## Staff Report Z-66-17-4 December 5, 2017

**Alhambra Village Planning Committee**

Request From: R1-6 (0.59 acres)

Proposed Use: Single-family attached residential -

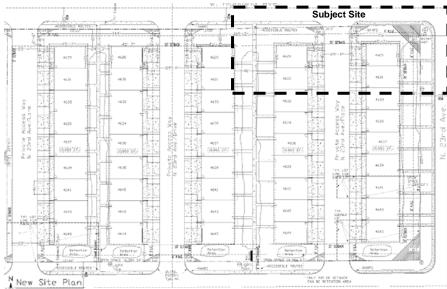
The conceptual site plan depicts approximately 4.00-acre planned residential development inclusive of the 0.59-acre subject site. The overall proposal includes 45 single-family attached (townhouses).

- 7. The site plan depicts attached sidewalks along the perimeter of the development. To encourage walkability and shade, staff is recommending a stipulation that all sidewalks be detached with a minimum five-foot-wide landscape strip located between the sidewalk and back of curb and shall include a minimum 2-inch caliper shade trees planted a minimum 20 feet on center or equivalent groupings along both sides of the sidewalks. This design is consistent with the City Council adopted Guiding Principles for Complete Streets, one tenet of which is to make Phoenix more walkable. This is addressed in Stipulation 1.

- 1. All sidewalks shall be detached with a minimum five-foot-wide landscaped strip located between the sidewalk and back of curb and shall include a minimum 2-inch caliper shade trees planted a minimum of 20 feet on center or equivalent groupings along both sides of the sidewalk, as approved by the Planning and Development Department.
